GARDINER EXPRESSWAY AND LAKE SHORE BOULEVARD EAST RECONFIGURATION ENVIRONMENTAL ASSESSMENT

Appendix S – Road Safety Audit

SUBJECT: Gardiner-Lake Shore Boulevard East Reconfiguration EA – Safety Review Responses

Subject Waterfront Toronto – Gardiner-DVP Ramps Road Safety Audit

FIGURE 1: SAFETY ANALYSIS SECTIONS

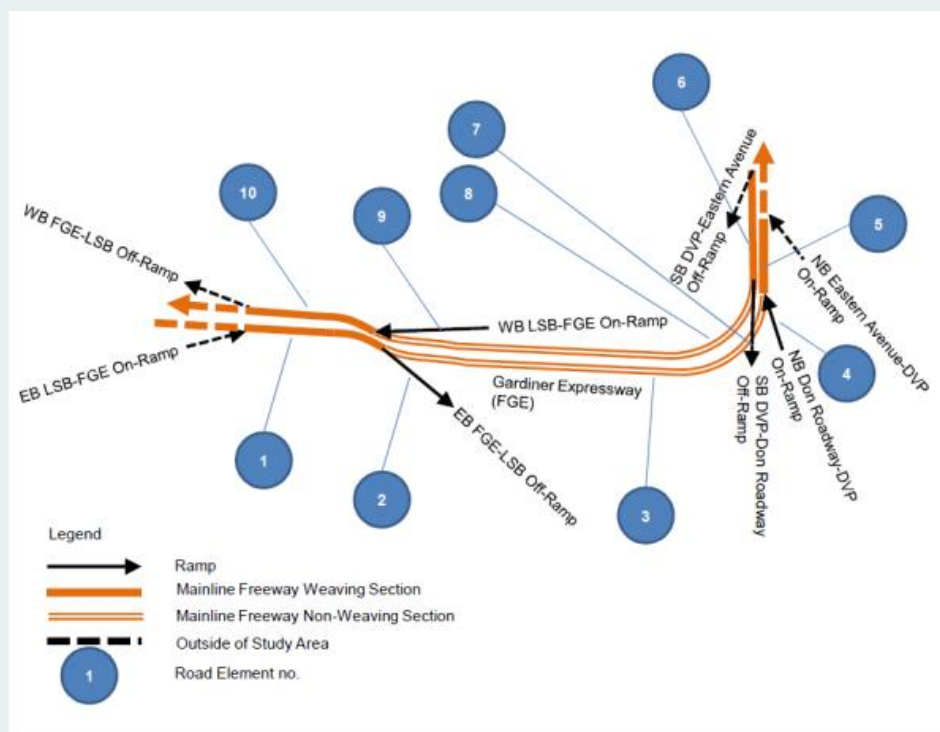
ID #	AECOM Comment	Dillon Response	Mitigation Reference
PART A: Comments & Responses By Road Element			
Road Element #1: Eastbound FGE between the Jarvis Street On-Ramp and the New LSB EB Off-ramp			
Alternative 1

1.	Potential One-Sided Weaving / Speed Differential Issue with cars entering FGE at Jarvis exiting at the FGE-DVP W-N ramp. Potential Sightline Issue at the downstream bullnose	Agree that this is a potential issue with Alternative 1 that has the DVP exit on the median side. This condition is improved with Alternatives 2A and 3 where the DVP exit is on the right side.	23
Alternatives 2A and 3

2.	Potential Sightline Issue at the downstream bullnose	The bull nose is located 40 m east of the road high spot and is 0.96 m below the high spot in elevation. Although there is a sightline issue (ability to see the road service at the bullnose from west of the high spot) a vehicle stopped at the bullnose, as well as any bullnose signage/hazard warning, will be visible. Shifting the bullnose location to the west and/or moving the vertical curve high spot further east should be reviewed during the design phase. Note that the desire, from an urban design/aesthetic standpoint, to minimize any Gardiner deck widening over the Cherry Street corridor, led to the positioning of the new exit bullnose to the east side and matching the vertical profile of the Gardiner to the west (with its highpoint).	27

3.	Potential for Violation of Drivers' Expectations (left side ramp exit to LSB)	Acknowledged	23
Road Element #2: FGE Eastbound Off-Ramp to LSB			
Alternative 1

Figure 1 – Study Area Map

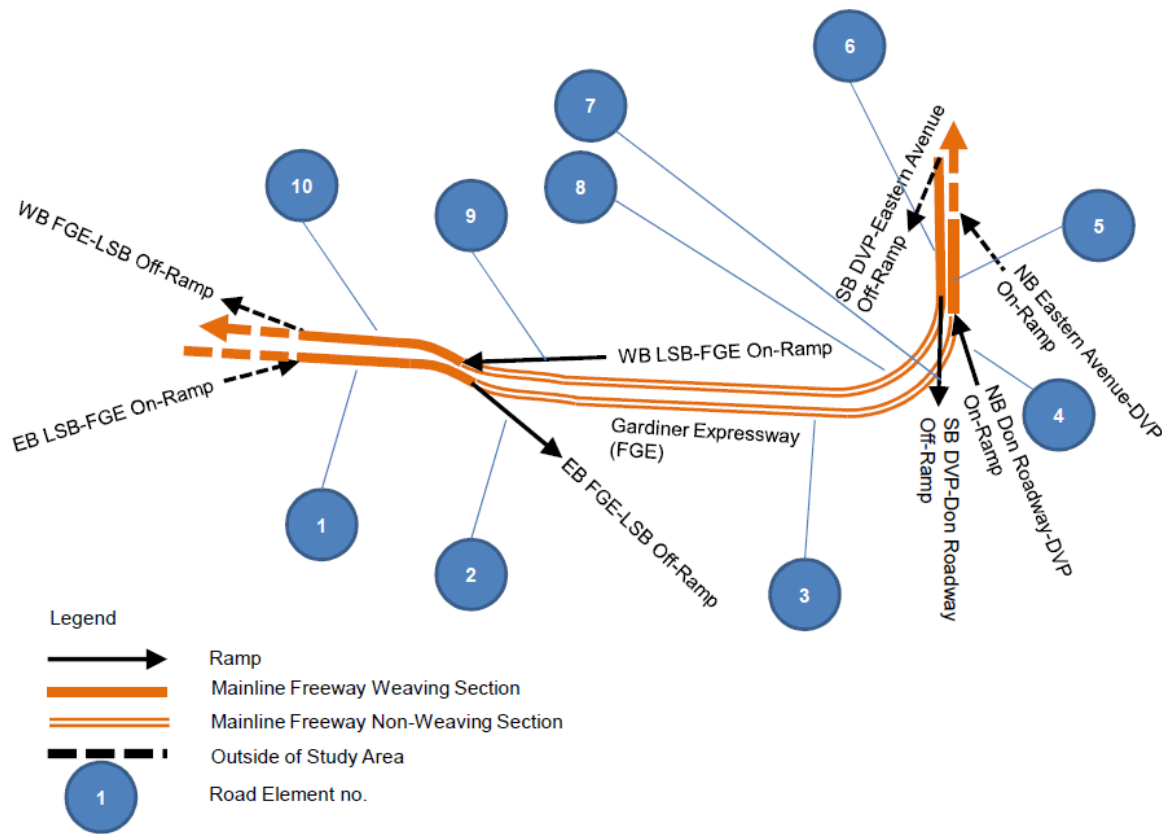
Road Element no.	Road Element Description	Alternative #1	Alternative #2A	Alternative #3
1	Eastbound FGE Mainline Section between Tip of Painted Gore Area of Eastbound LSB-FGE On-Ramp (i.e., Lower Jarvis On-Ramp) and Tip of Painted Gore Area of Eastbound FGE-LSB Off-Ramp (i.e., the “fork”)	<p><u>Potential One-Sided Weaving / Speed Differential Issue:</u> Relatively high volume of motorists (estimated at maximum of 1’130 vehicles during the PM peak hour⁹) entering FGE from the uphill LSB-FGE on-ramp (i.e., Lower Jarvis on-Ramp) and destined to DVP northbound direction are to accelerate to the “assumed” speed and make two lane changes to the left through relatively high volume of motorists (estimated at maximum of 1’846 vehicles during the PM peak hour¹⁰) on FGE and heading to LSB off-ramp (as well as a portion of motorists on FGE and heading to DVP north) within a 450-m long weaving area. Even if proper signage is provided, for some drivers, the distance travelled during a summation of vehicle acceleration time, “reading time” (i.e., time to read, detect, and understand the to-be-provided overhead / side-mounted signs), “decision time”, “manoeuvre time” could be longer than the available weaving distance.</p> <p><u>Potential Sightline Issue:</u> Due to lane discontinuity at the “fork”, some drivers may not initiate lane changing manoeuvres until they see the exit bull nose of the downstream off-ramp (i.e.,</p>	<p><u>Potential Sightline Issue:</u> Due to lane discontinuity at the “fork”, some drivers may not initiate lane changing manoeuvres until they see the physical bull nose of the “fork”. To lesser extent in comparison to that of Alternative #1, sightline of some motorists on the two inside lanes to the exit bull nose could be blocked by the parapet walls and due to presence of a horizontal curve ahead of the “fork”.</p> <p><u>Potential for Violation of Drivers’ Expectations:</u> Considering the existing lay-out with exit ramp to LSB on the right side, a left exit to LSB may violate drivers’ expectations; locating the off-ramp on the left side may violate drivers’ expectations in the short run (i.e., during initial period after opening to public). In addition, the expected speed differential between the accelerating traffic destined to DVP and decelerating traffic exiting FGE onto LSE off ramp on the inner lanes could create a potential for rear-end collisions.</p>	<p><u>Potential Sightline Issue:</u> Due to lane discontinuity at the “fork”, some drivers may not initiate lane changing manoeuvres until they see the physical bull nose of the “fork”. To lesser extent in comparison to that of Alternative #1, sightline of some motorists on the two inside lanes to the exit bull nose could be blocked by the parapet walls and due to presence of a horizontal curve ahead of the “fork”.</p> <p><u>Potential for Violation of Drivers’ Expectations:</u> Considering the existing lay-out with exit ramp to LSB on the right side, a left exit to LSB may violate drivers’ expectations; locating the off-ramp on the left side may violate drivers’ expectations in the short run (i.e., during initial period after opening to public). In addition, the expected speed differential between the accelerating traffic destined to DVP and decelerating traffic exiting FGE onto LSE off ramp on the inner lanes could create a potential for rear-end collisions.</p>

Road Element no.	Road Element Description	Alternative #1	Alternative #2A	Alternative #3
		the “fork”). Sightline of some motorists on the outside lane and the adjacent lane to the exit bull nose could be blocked by the parapet walls and due to presence of a horizontal curve ahead of the “fork”.		
2	Eastbound FGE-LSB Off-Ramp	<u>Potential Sightline Issue:</u> The to-be-retained existing bridge piers (of the elevated eastbound FGE mainline section) and inside parapet walls of the off-ramp may obstruct sightlines for exiting motorists on approach to the intersection of Munition Street; approaching motorists’ sightlines to end of eastbound vehicles queue may be blocked by the bridge piers and inside parapet walls. This can be of a greater issue in the absence of appropriate lighting for the underpass section of the off-ramp. The proposed design of the ramp with a 5%-downgrade slope followed by a horizontal curve would likely not provide unobstructed sightlines for motorists to make necessary collision avoidance manoeuvres, if needed.	<u>Potential Sightline Issue:</u> Stopping sight distance appears not to be available at the western end due to presence of a crest vertical curve with K-value of 9 on top of the ramp (at STA.0+300). The proposed vertical arrangement would likely not provide unobstructed sightlines for motorists exiting FGE from the ramp to make necessary collision avoidance manoeuvres, if needed.	<u>Potential Sightline Issue:</u> Stopping sight distance appears not to be available at the western end due to presence of a crest vertical curve with K-value of 9 on top of the ramp (at STA.0+300). The proposed vertical arrangement would likely not provide unobstructed sightlines for motorists exiting FGE from the ramp to make necessary collision avoidance manoeuvres, if needed.

3	Eastbound FGE-DVP Ramp ¹¹	Based on field observations, there is a narrower-than-standard shoulder width for emergency purposes along the curved eastern portion. No further comment - Profile drawing and design speed are needed for further review, if available.	<u>Potential for Violation of Drivers’ Expectations:</u> FGE’s tangential (straight) and fairly level alignment on approach to the horizontally curved portion of the ramp (with design speed of 60 km/h) is perceived by some drivers as a notion that they can operate safely at speed of 90 km/h or even higher. Hence, drivers’ expectations could be violated.	<u>Potential for Violation of Drivers’ Expectations:</u> FGE’s tangential (straight) and fairly level alignment on approach to the horizontally curved portion of the ramp (with design speed of 60 km/h) is perceived by some drivers as a notion that they can operate safely at speed of 90 km/h or even higher. Hence, drivers’ expectations could be violated.

Road Element no.	Road Element Description	Alternative #1	Alternative #2A	Alternative #3
			<p><u>Potential Sightline / Increased Driver Workload / Vehicle Instability Issues:</u> Along the curved eastern portion of the ramp, motorists sightline could be blocked by the inside parapet walls. This is coupled with presence of a crest vertical curve with K-value of 8 followed by a 6.5% downgrade along the curved portion of the ramp at STA.1+040; this creates a potential for sightline obstruction for motorists negotiating the curved portion of the ramp in an environment with heavy workload for drivers to adjust their vehicles' lane positioning and a potential for vehicle instability. Proposed geometry would likely not provide necessary unobstructed sight lines for collision avoidance manoeuvring.</p>	<p><u>Potential Sightline / Increased Driver Workload / Vehicle Instability Issues:</u> For a shorter distance in comparison to that of Alternative #2, along the curved eastern portion of the ramp, motorists sightline could be blocked by the inside parapet walls. This is coupled with presence of a crest vertical curve with K-value of 6 followed by a 6.9% downgrade along the curved portion of the ramp at STA.1+000; this creates a potential for sightline obstruction for motorists negotiating the curved portion of the ramp in an environment with heavy workload for drivers to adjust their vehicles' lane positioning and a potential for vehicle instability. Proposed geometry would likely not provide necessary unobstructed sight lines for collision avoidance manoeuvring.</p>

Road Element no.	Road Element Description	Alternative #1	Alternative #2A	Alternative #3
6	Southbound DVP Mainline Section between Tip of Painted Gore Area of DVP-Eastern Avenue Off-Ramp and Tip of Painted Gore Area of DVP-LSB Off-Ramp	No issues identified.	No issues identified.	<u>Potential for Speed Differentials</u> : Shorter than standard speed-change lane at exit terminal.
7	Southbound DVP-Don Roadway Off-Ramp	Not reviewed - Profile drawing is needed for further review, if available.	<u>Potential Sightline Issue</u> : Stopping sight distance appears not to be available for motorists exiting DVP from the ramp due to presence of a crest vertical curve with K-value equal to 4 at STA.0+300.	<u>Vertical Clearance Issue</u> : Elevated westbound DVP-FGE ramp located above would create vertical clearance issue for motorists exiting DVP from Don Roadway off-ramp.
8	Westbound DVP-FGE Ramp ¹²	Based on field observations, there is a narrower than standard shoulder width for emergency purposes along the curved eastern portion. No further comment - Profile drawing and design speed are needed for further review, if available.	<u>Potential Sightline / Increased Driver Workload</u> : Along the curved eastern portion of the ramp, motorists' sightlines could be blocked by the outside parapet walls in an environment creating heavy workload for drivers to adjust their vehicles' lane positioning. Proposed geometry would likely not provide necessary unobstructed sight lines for collision avoidance manoeuvring.	<u>Potential Sightline Issue / Increased Driver Workload Issue</u> : For a shorter distance in comparison to that of Alternative #2A , along the curved eastern portion of the ramp, motorists' sightlines could be blocked by the outside parapet walls in an environment with heavy workload for drivers to adjust their vehicles' lane positioning. Proposed geometry would likely not provide necessary unobstructed sight lines for collision avoidance manoeuvring. <u>Potential for Speed Differentials</u> : Trucks may experience significant loss of speed (especially in icy road conditions) due to presence of a 6.9% upgrade along the curved portion of the ramp.

Road Element no.	Road Element Description	Alternative #1	Alternative #2A	Alternative #3
9	Westbound LSB-FGE On-Ramp	No issues identified.	<u>Potential Sightline Issue:</u> Stopping sight distance appears not to be available for entering motorists from the ramp to FGE due to presence of a crest vertical curve with K-value of 6 at the top of the ramp (STA.0+310).	<u>Potential Sightline Issue:</u> Stopping sight distance appears not to be available for entering motorists from the ramp to FGE due to presence of a crest vertical curve with K-value of 6 at the top of the ramp (STA.0+310).
10	Westbound FGE Mainline Section between Tip of Painted Gore Area of Westbound LSB-FGE On-Ramp and Tip of Painted Gore Area of Westbound FGE-LSB Off-Ramp (i.e., Sherbourne Off-Ramp)	<u>Potential One-Sided Weaving Issue:</u> Relatively low volume (estimated at maximum of 389 vehicles during the AM peak hour ¹³) of motorists entering FGE from the westbound DVP-FGE ramp and destined to Sherbourne Street off-ramp are to accelerate to the “assumed” speed and make two lane changes to the right through relatively high volume (estimated at maximum of 2,284 vehicles during the AM peak hour ¹⁴) of motorists entering from LSB on-ramp and intended to continue travelling west along FGE within a 420-m long weaving area.	<u>Potential Two-Sided Weaving Issue:</u> Relatively low volume (estimated at maximum of 389 vehicles during the AM peak hour ¹⁵) of motorists entering FGE from the westbound DVP-FGE ramp and destined to Sherbourne Street off-ramp are to accelerate to the “assumed” speed and make two lane changes to the right through relatively high volume (estimated at maximum of 2’587 vehicles during the AM peak hour ¹⁶) of motorists entering from LSB on-ramp and intended to continue travelling west along FGE within a 420-m long weaving area.	<u>Potential Two-Sided Weaving Issue:</u> Relatively low volume (estimated at maximum of 389 vehicles during the AM peak hour ¹⁷) of motorists entering FGE from the westbound DVP-FGE ramp and destined to Sherbourne Street off-ramp are to accelerate to the “assumed” speed and make two lane changes to the right through relatively high volume (estimated at maximum of 2’587 vehicles during the AM peak hour ¹⁸) of motorists entering from LSB on-ramp and intended to continue travelling west along FGE within a 420-m long weaving area.
